Hwy. 417 & Co. Rd. 13

MEMORANDUM

FOUNDATION INVESTIGATION REPORT

The Proposed Underpass Structure at the
Crossing of Hwy. #417 and Co. Rd. #13
Twp. of E. Hawkesbury, County of Prescott
District No. 9 (Ottawa)

FIGURE NO. 5

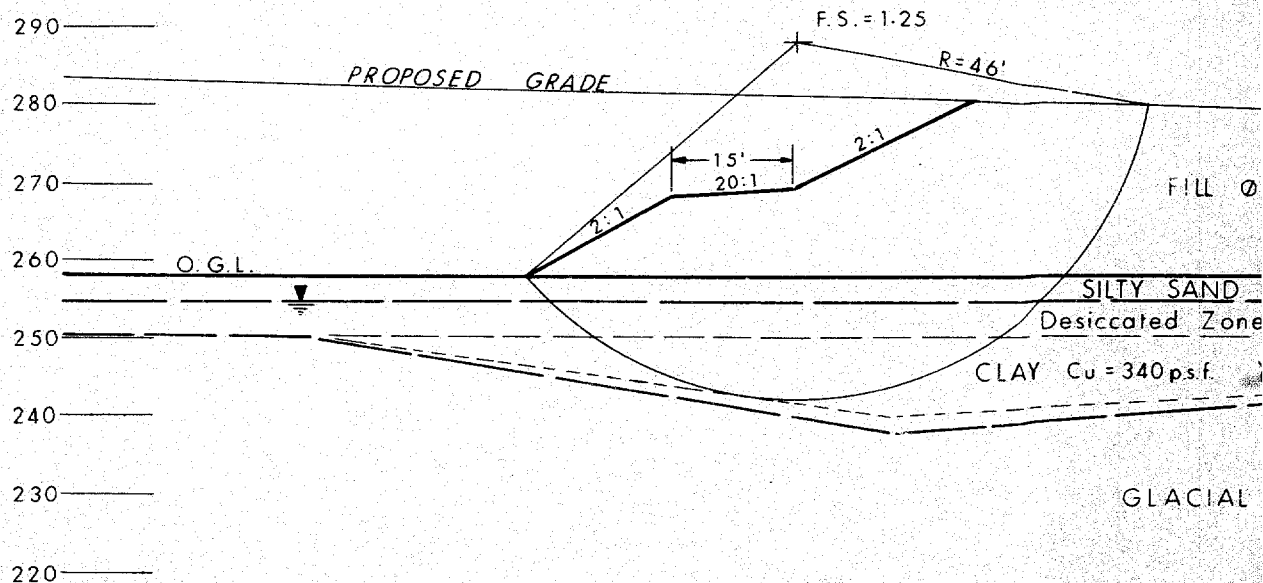
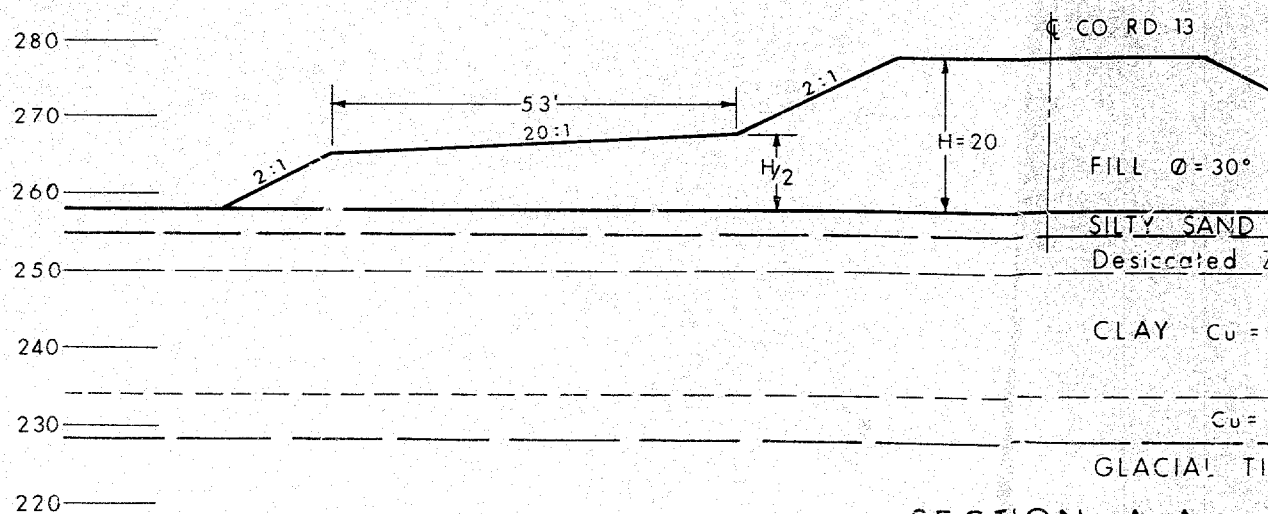
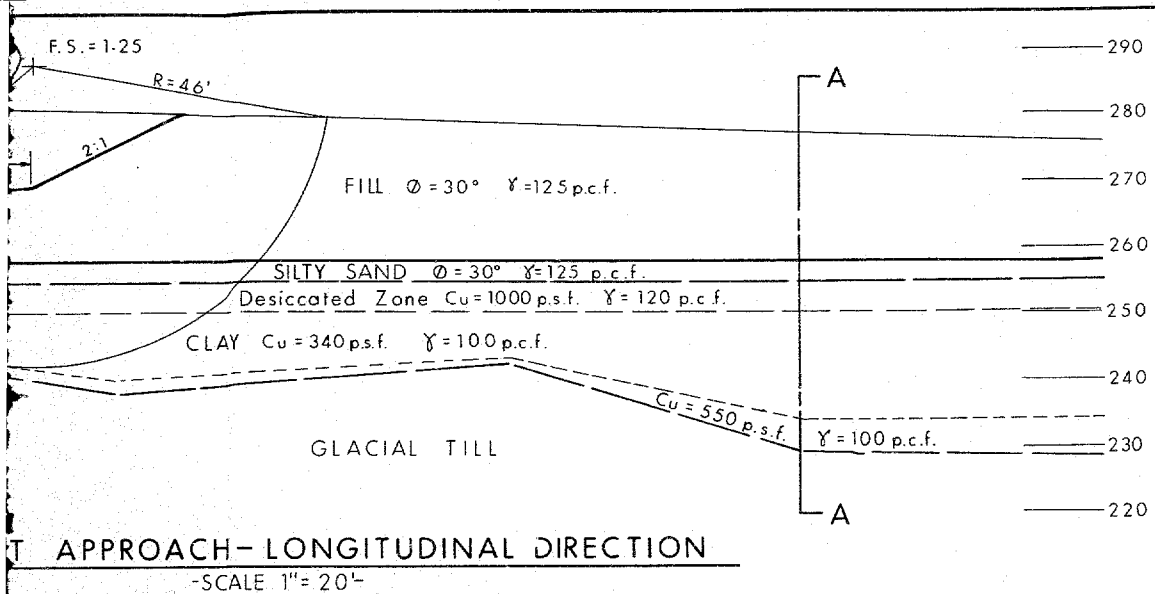
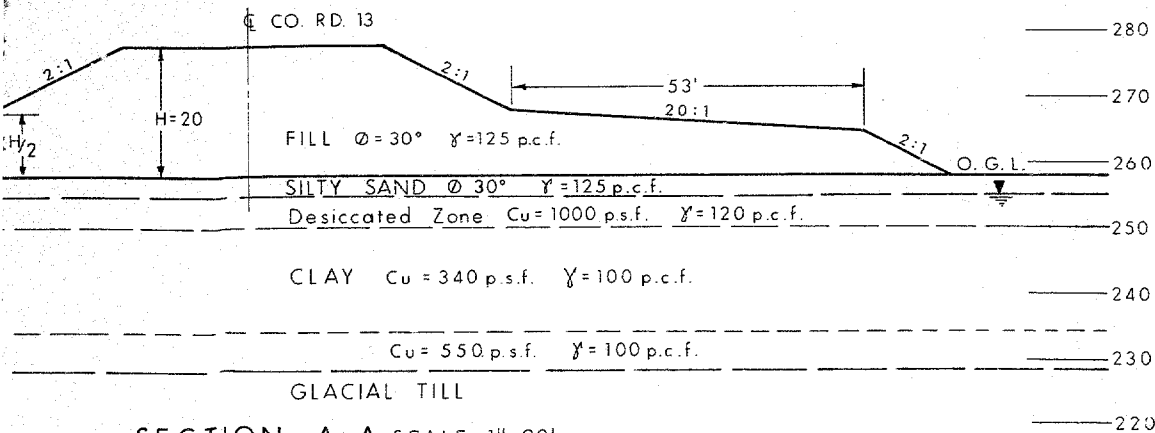
There is a conflict in the depth of excavation between the longitudinal direction (profile) drawing and the section A-A.

Apparently the longitudinal drawing shows the proposed grade on centre-line although the depth of excavation shown appears to be plotted from the offset borings. The section, however, shows a reasonable interpolation of the depth of excavation on centreline.

On our cross-section roll, we have used the bore hole data as shown on your drawing No. 70-11082A, and interpolated cross-sectionally and longitudinally as required.

HWY. No. 417 & CO. ROAD 13 - EAST APPROACH

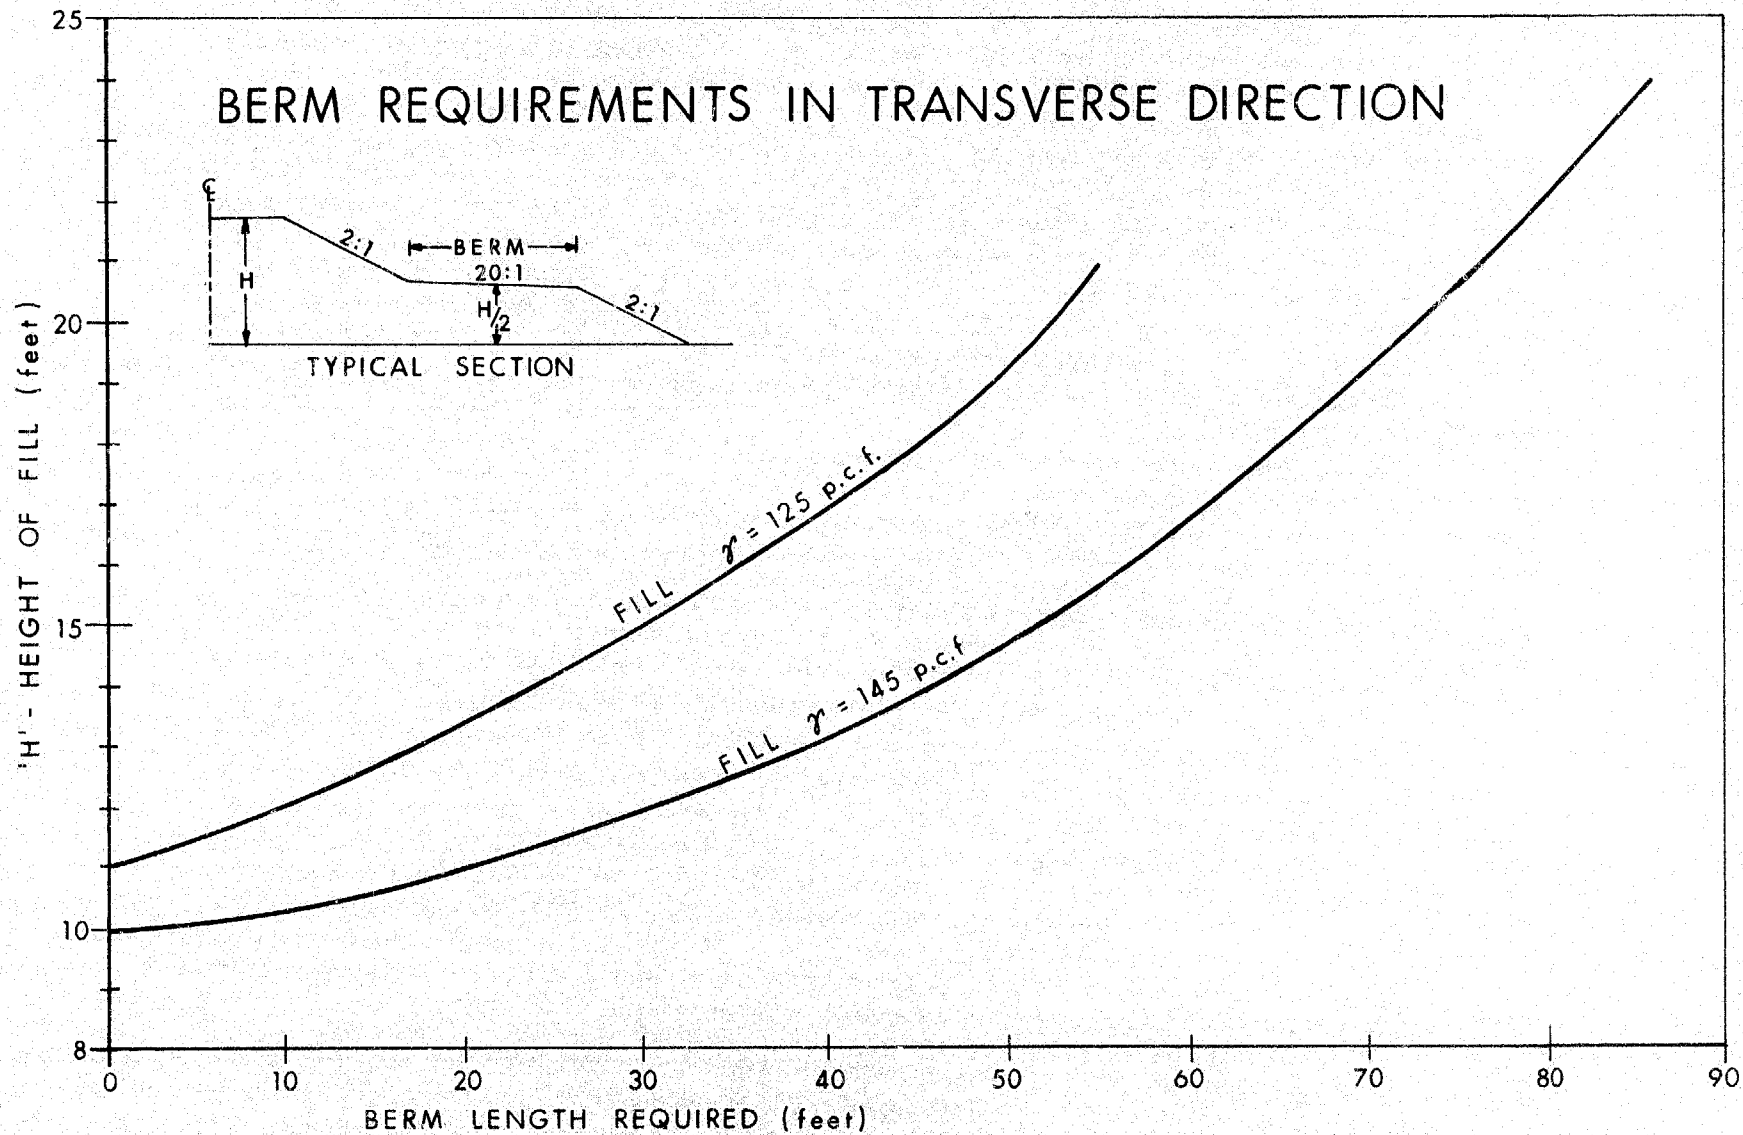
BASED ON THE PRE-ENGINEERING SOILS DATA IN THIS AREA, THE PROPOSED
FILLS WILL CONSIST OF A GRANULAR TYPE GLACIAL TILL WITH A UNIT
WEIGHT OF 140-145 LBS. WOULD THIS EFFECT THE RESULTS OF YOUR
STABILITY ANALYSIS, AS YOU ASSUMED 125 LBS. PLEASE REVIEW AND REPLY.

Further to your teletype we have reviewed the berm requirements along the aforementioned approach taking into consideration that a granular type of glacial till, with a compacted in-place bulk unit weight of the order of 140 to 145 p.c.f., will be used as fill on this site. In the foundation report previously submitted an in-place bulk unit of 125 p.c.f. was assumed for the fill for computational purposes. The berm requirements, along the east approach, for the latter fill weight were summarized on Figure #4 in the report.

The mid-height berms, in the transverse direction along the east approach, will have to be longer than those proposed in the report in order to allow for the fact that the fill will have a higher in-place unit weight than that originally assumed. The proposed berm lengths, in this direction, for various heights of fill are plotted on the figure attached to this letter. A berm will not be required in the longitudinal or forward direction along this approach since the soft compressible cohesive stratum is to be completely sub-excavated in this area.

Berm reqd. 86' agreed
by Found. office Sept 22/71

APPROVED	BRIDGE ENGINEER	SITE No.	27-222	W.P. No.	37-66-09
DESIGN	G.A.	CHECK	Y.V.	CONTRACT	No.
DRAWING	A.A.	CHECK	G.A.	DRAWING	No.
DATE	AUG. 1/71	LOADING	HS20-44	D-6973-1

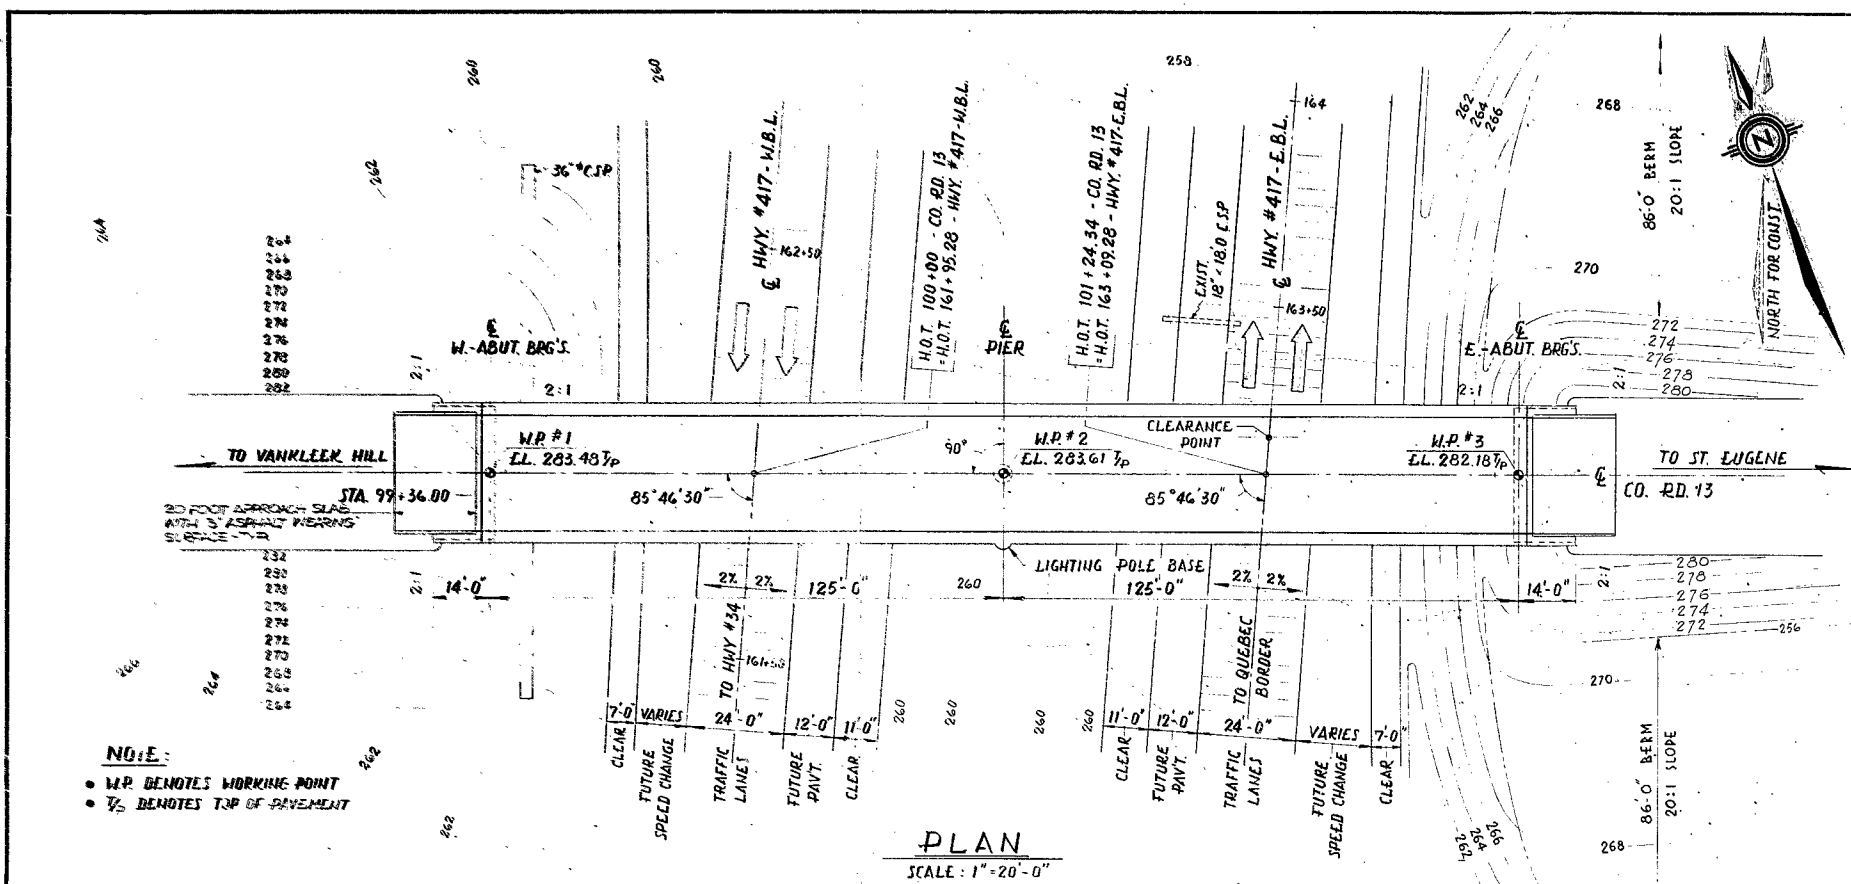
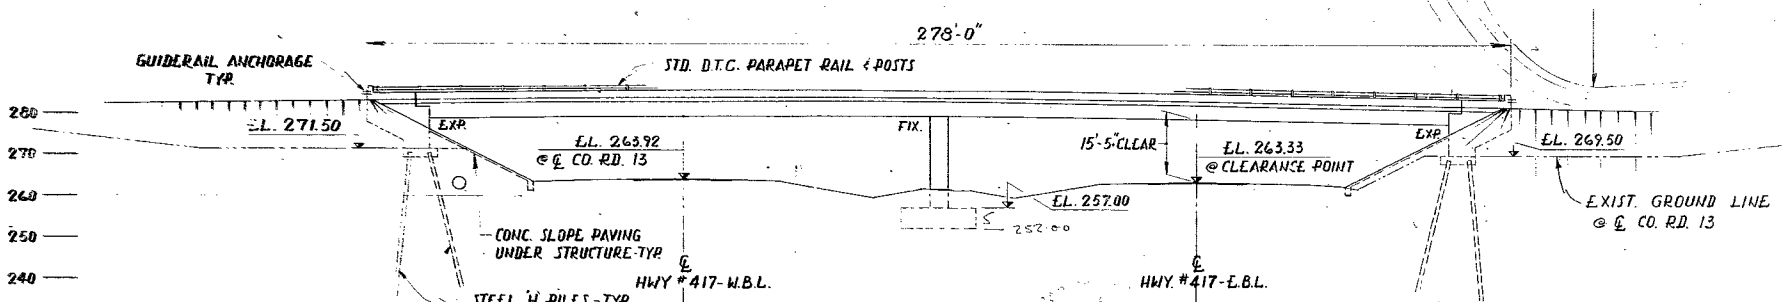
We have reviewed Bridge Drawings No. D-6973-1 and 3 for the
aforementioned structure and submit the following comments:

The berms in the transverse direction, along the east
approach, will have to be longer than those recommended
in the foundation report for this structure (refer to
Figure #4 in the report). This is necessary because
the in-place bulk unit weight of the material to be
used as fill on this site will be higher than that assumed
in the report (145 p.c.f. compared to 125 p.c.f. as
per teletype from Mr. E. R. Saint, Regional Materials
Engineer, Eastern Region). The revised berm lengths for
various fill heights are plotted on the figure attached
to this letter

*86' long berms provided in Transverse
direction at abutments.*

Enclosed for your information are three prints of revised plan D6973-1. The length of the side berms at the East approach has been increased to 86' to comply with the latest recommendations of the Foundation Section.
